DSDIP Reference: RPI25/007

REQUIREMENT NOTICE RESPONSE

RPI25/007: Santos - Yuleba

Santos has prepared a response to the requirement notice (**RN**) issued to Santos on 12 August 2025 for the Regional Interest's Development Approval (**RIDA**) for a resource activity: petroleum and gas for the Yuleba Project in the Yuleba Priority Living Area (**PLA**). Responses to the RN are provided in Table 1 below.

AREA 0007 - STANDARD DRAWING	
WELLPAD FIELD ACCESS ROAD (MODIFIED CLASS E)	
TYPICAL CROSS SECTION	
Santos GLNG	DRAWING No. 0007-040-GAR-0040
	REV 3

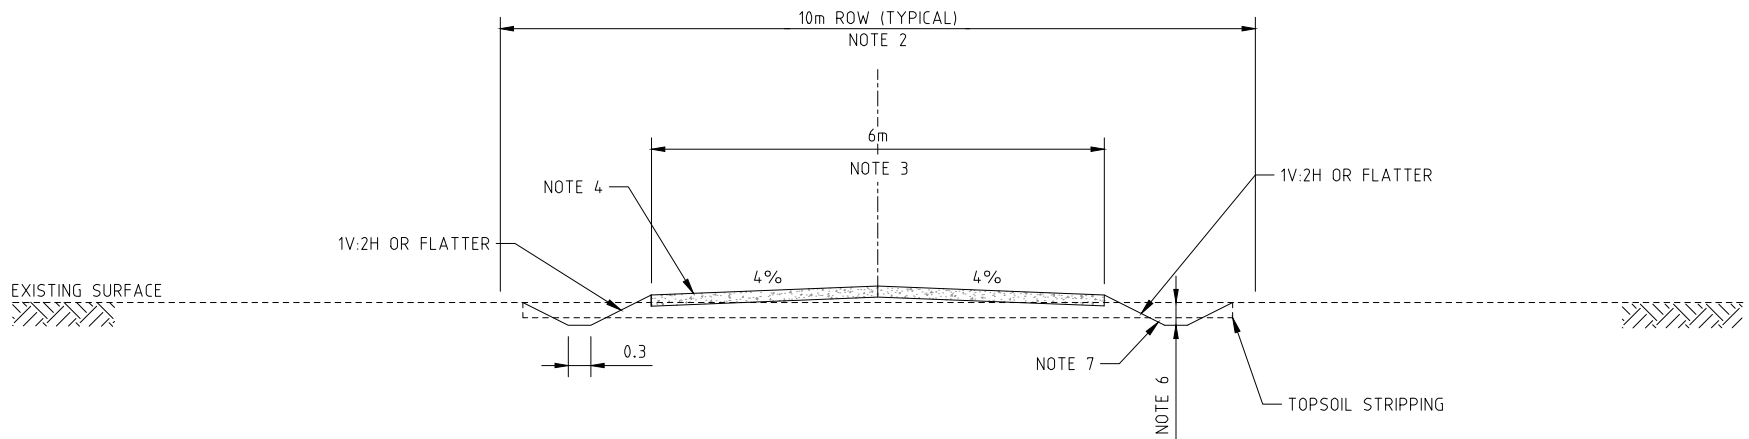
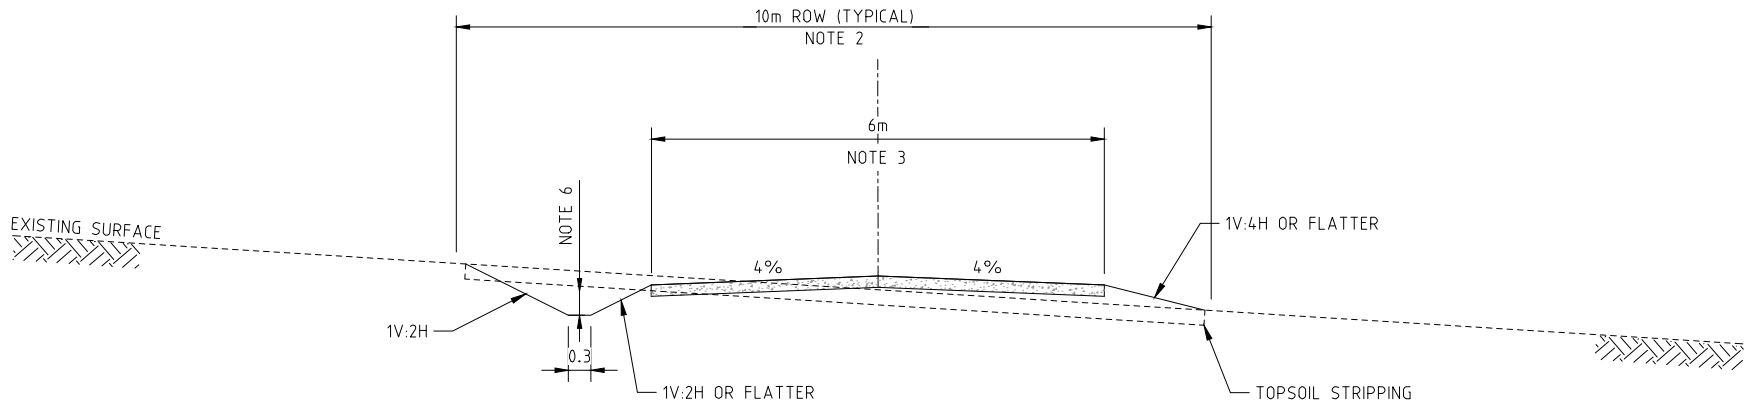
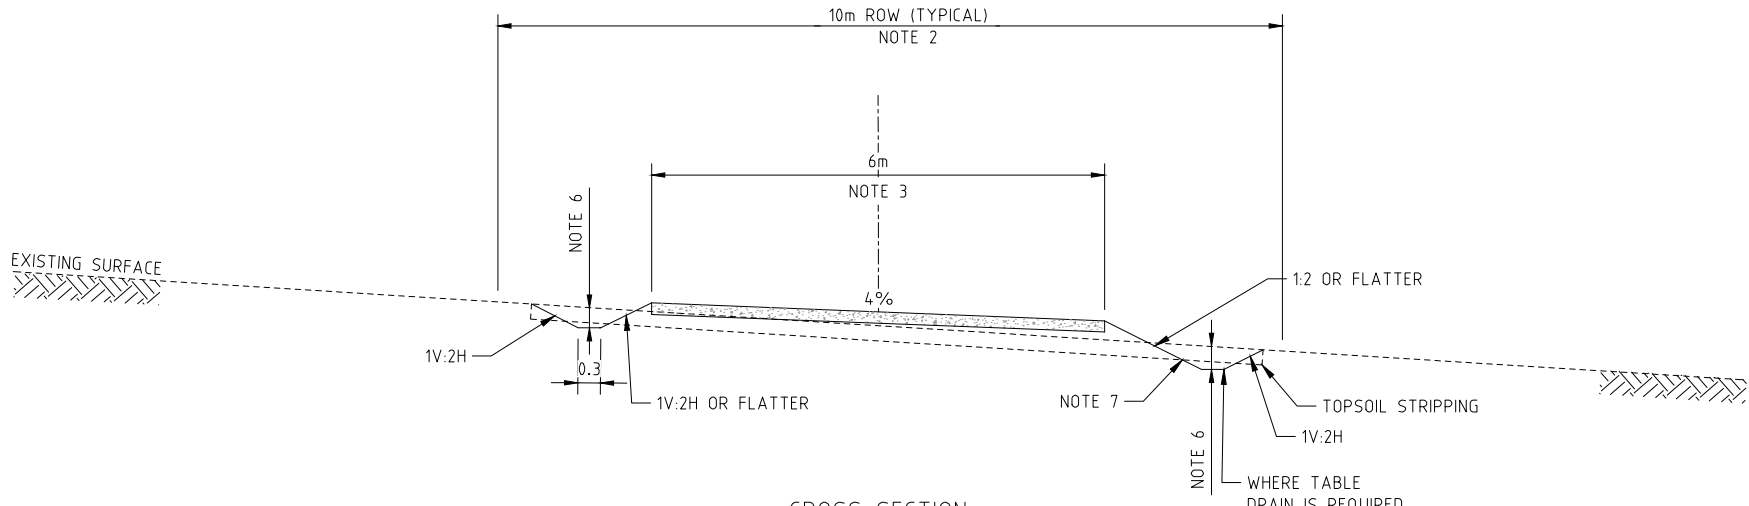
2.	<u>Traffic Impacts Issue:</u> The application material indicates that the proposed activities may have the potential to introduce additional traffic impacts within the Priority Living Area, however no details have been provided to quantify the likely impacts and any required mitigation measures. <u>Actions:</u> (a) Provide details of the vehicle types and volumes of traffic generated by the proposed activities (during construction and operational phases), identifying the likely impacts on both local and state-controlled road networks. (b) Identify all proposed access locations and proposed upgrades/treatments at these locations, including the proposed use of the existing access to the Warrego Highway (Northwest Project Area). (c) Confirm that the location and extent of road reserve that will be impacted by the development is limited to the “New Access Road” identified as Item 8 in Figure 5 (Northeast Project Area). (d) Provide details of the proposed road construction for Item 8 “New Access Road” and any other road reserves if applicable (Northeast Project Area) (e) Provide design details for Item 9 “New Road Turnout” (Northeast Project Area).	(i) South-west project area – 2 wells will be accessed from Yuleba Surat Road in relation to the PLA, one of which is the well pad located partially within the PLA (identified as item 2 in section 4.4.1). It is expected that up to 15 light vehicles and 5 heavy vehicles per day for a duration of 1 month will be required during the construction phase, and up to 4 light vehicle movements per month for the life of the wells during the operational phase. Yuleba Surat Road is a secondary branch off the Warrego Highway which is a major highway linking Roma and Brisbane. As highly trafficked main roads, the proposed traffic will have a minimal impact on traffic flows in the PLA. ii) North-west project area - 2 wells located outside the PLA may be accessed from the Warrego Highway within the PLA (primary access will be from the existing road (Field Road) to the North. It is expected that up to 15 light vehicles and 5 heavy vehicles per day for a duration of 1 month will be required during the construction phase, and up to 4 light vehicle movements per month for the life of the wells during operational phase. The Warrego Highway is a major highway linking Roma and Brisbane. As a highly trafficked main road, the proposed traffic will have a minimal impact to existing traffic flows in the PLA. iii) North-east project area - 7 wells located outside the PLA will be accessed from the Yuleba Taroom Road within the PLA. It is expected that up to 16 light vehicles and 6 heavy vehicles per day for a duration of 3.5 months will be required during the construction phase, and up to 6 light vehicle movements per month for the life of the wells during operational phase. The Yuleba Taroom Road is a secondary branch off the Warrego Highway. The proposed traffic will have a minimal impact on existing traffic flows in the PLA. Likely impacts and mitigation measures The most intense traffic generated (during construction phases) will occur over a limited period and will utilise existing roads or temporary access tracks designed in a manner broadly consistent with the form and scale of traffic generated by the surrounding and existing rural infrastructure and land uses. As access will be via the Warrego Highway and other heavily trafficked roads (Yuleba Surat Road and

- (d) Road constructions will follow the Santos Standard access road design as per attached file 0007-040-GAR-0040_3 (Appendix 1, identified in the updated RIDA as Appendix D). Santos' road design and construction methods will meet relevant specifications stipulated by the Department of Transport and Main Roads (DTMR) and Maranoa Regional Council.
- (e) Please see attached Santos Standard turnout design drawing 0007-040-GAR-0072 (Appendix 2 identified in the updated RIDA as Appendix E).
